Section 2 Public and Common Use Areas

The public and common use areas of Jefferson Pines Apartments are required to be readily accessible to and usable by persons with disabilities. The public and common use areas of this complex include the following:

*Threshold
Measurement -
Exterior(#9975),left*

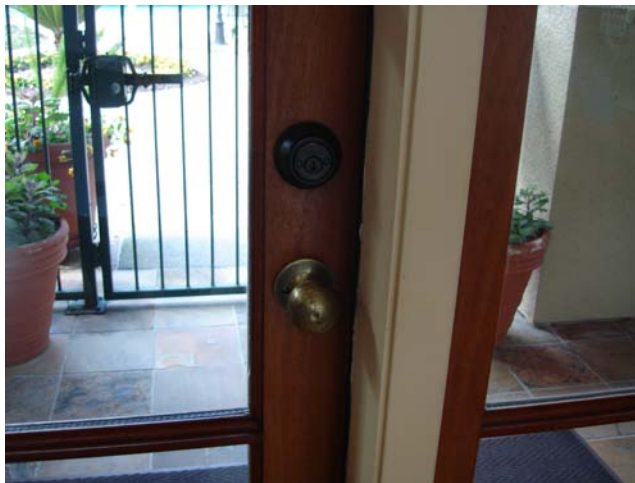
The front door threshold was more than 1-1/8 inches high at the exterior side and 1 inch high at the interior. This is more than the 1/2 inch high threshold maximum height (ANSI 4.13.8).

Fitness Room (#00070)

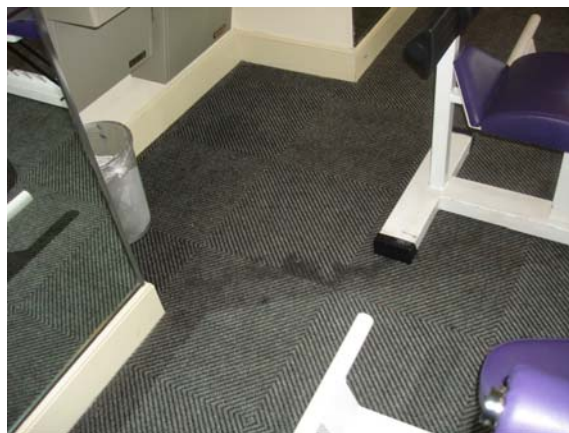
The equipment was located in the room in such a way that access to all types of equipment was not possible for person using a wheelchair.

Access to the drinking fountain and to the women's restroom was blocked by the equipment. The passage to the drinking fountain was 22 inches wide on one side and 24 inches on the other. The equipment also blocked the clear floor space at the fixture. The equipment was not easily movable by a single person. (ANSI 4.15.5).

Hook in toilet stall (#0143)

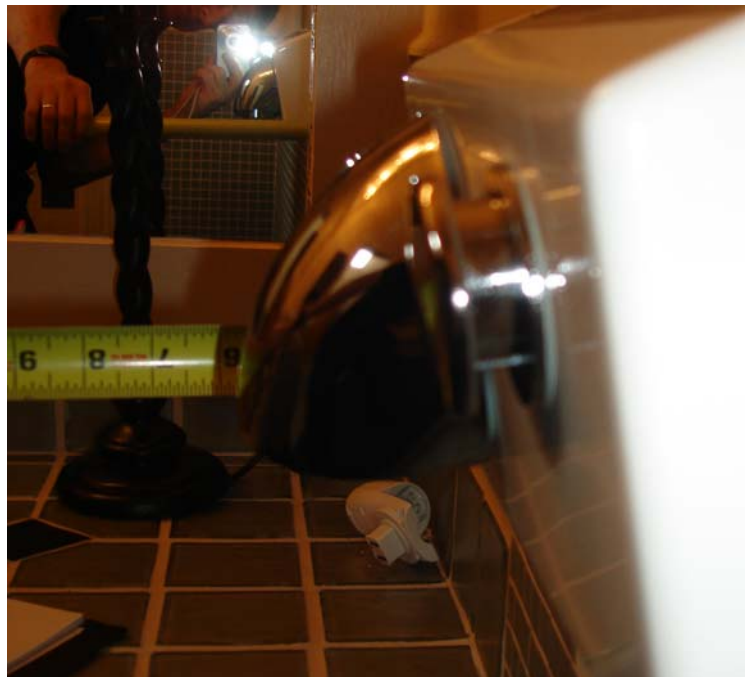
The hooks in the toilet stall were at 67-1/2 and 69 inches above the floor which is above reach range (ANSI 4.2.5, 4.2.6).
